Access Compliance Report

Public Rights-of-Way

Intersection ID: 15324	Main Street: ELMHURST_RD	Cross Street: SOUTH_BV	Location: NE
ADA ID: 52653721D45A	Ramp Type: Directional1	Initial Pass/Fail: Fail	Overall Compliance: No
Severity Score: 1.25			
Codes/Mitigation Info/Possible Solution		Field Measurements/Component Compliance

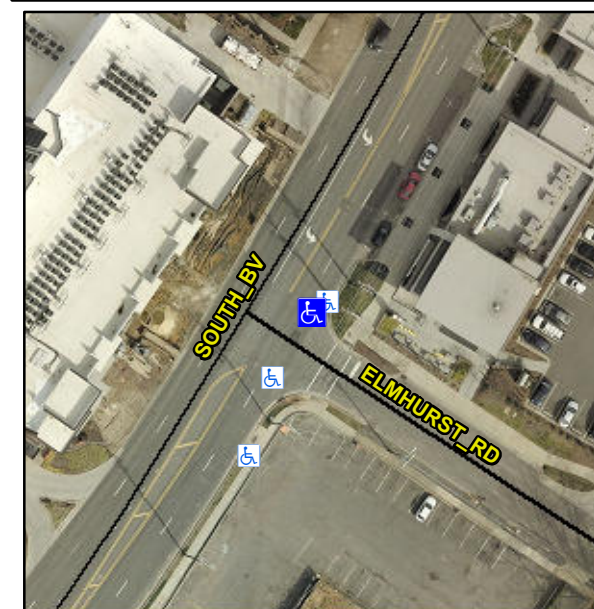
R304.5.3

Compliance	Description	Data	Compliance	Description	Data
N/A	Ramp Length (in)	48.0	N/A	Grade Break?	N/A
Yes	Ramp Width (in)	72.0	N/A	Grade Break Slope (%)	0.0
Yes	Ramp Slope (%)	4.5	N/A	Grade Break XSlope (%)	0.0
No	Ramp XSlope (%)	2.1			
N/A	Flare Type LT	N/A	N/A	Flare Type RT	N/A
N/A	Flare Slope LT (%)	N/A	N/A	Flare Slope RT (%)	0.0
N/A	Flare Traversable LT?	N/A	N/A	Flare Traversable RT?	N/A
N/A	Landing Length (in)	0.0	N/A	DWS Provided?	N/A
N/A	Landing Width (in)	0.0	N/A	DWS Contrast?	N/A
N/A	Landing Slope (%)	0.0	N/A	DWS Length (in)	N/A
N/A	Landing X Slope (%)	0.0	N/A	DWS Full Width?	N/A
N/A	Landing Curb? (Y/N)	N/A	N/A	DWS Offset LT (in)	N/A
N/A	Shared Landing?	N/A	N/A	DWS Offset RT (in)	N/A
N/A	Gutter Ponding?	0.0	N/A	Gutter Slope (%)	N/A
N/A	Gutter Lip Ht (in)	0.0	N/A	Gutter X Slope (%)	N/A
N/A	Painted X Walk1?	Yes		Road Slope (%)	2.6
	X Walk 1 Direction	To S		Road X Slope (%)	1.5
	X Walk 1 Width (in)	112.0		Clear Space?	N/A

Remove & Replace Entire Ramp.
